**Review of Performance Assessment and Composite Analysis for the Proposed Environmental Management Disposal Facility, Oak Ridge, Tennessee**

# A Review of the Performance Assessment and Composite Analysis for the Proposed Environmental Management Disposal Facility, Oak Ridge, Tennessee

12 October 2020

**Figure C 2. Mercury surface water concentrations in Bear Creek modeled in RESRAD-OFFSITE with different infiltration rate and  $K_d$  values.**

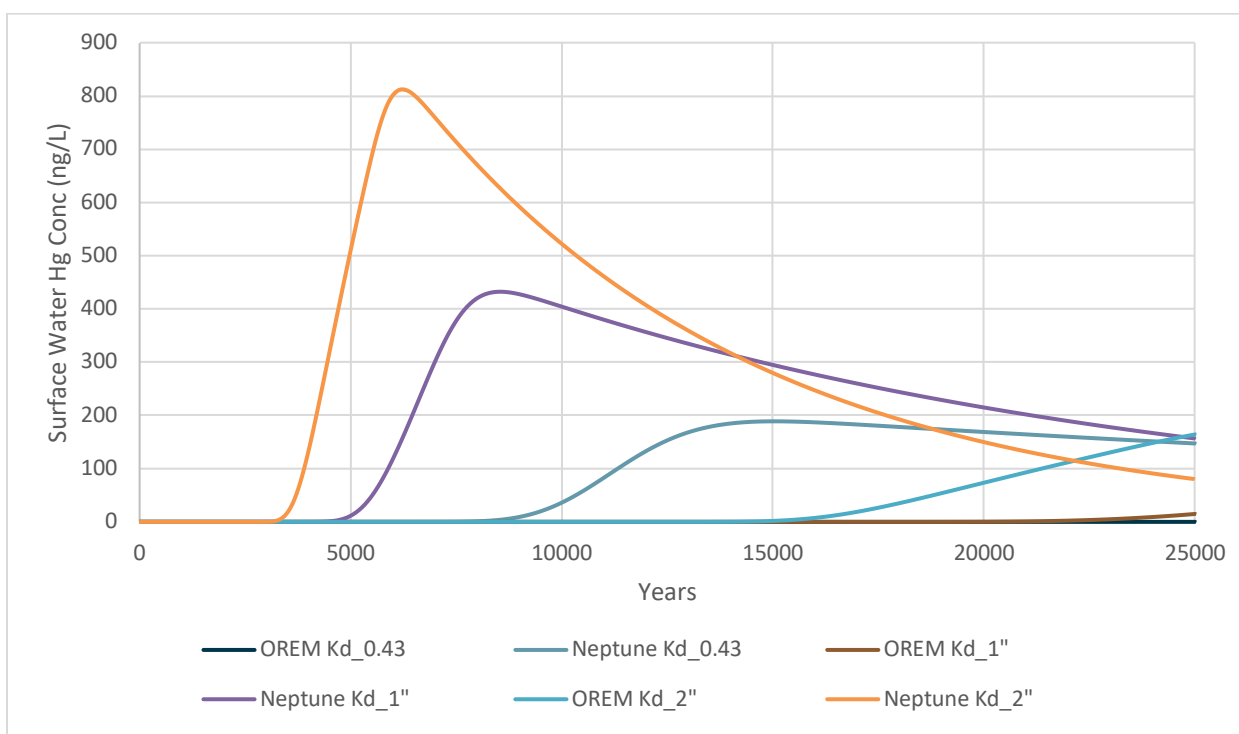
The results of the RESRAD-OFFSITE simulations for surface water mercury concentrations using different assumed values of infiltration rate and mercury  $K_d$  are shown in Figure C 2:

Note that neither the RESRAD nor the Neptune mercury  $K_d$  value may be applicable to mercury in the event that encapsulation or other treatment affects the partitioning behavior of mercury in the Y-12 waste. If elemental mercury is present in the waste these simulations are likely to be wholly inapplicable, as elemental mercury is insoluble in water but might migrate as a vapor or as a free-phase liquid at environmental temperatures. The chemical form of mercury released
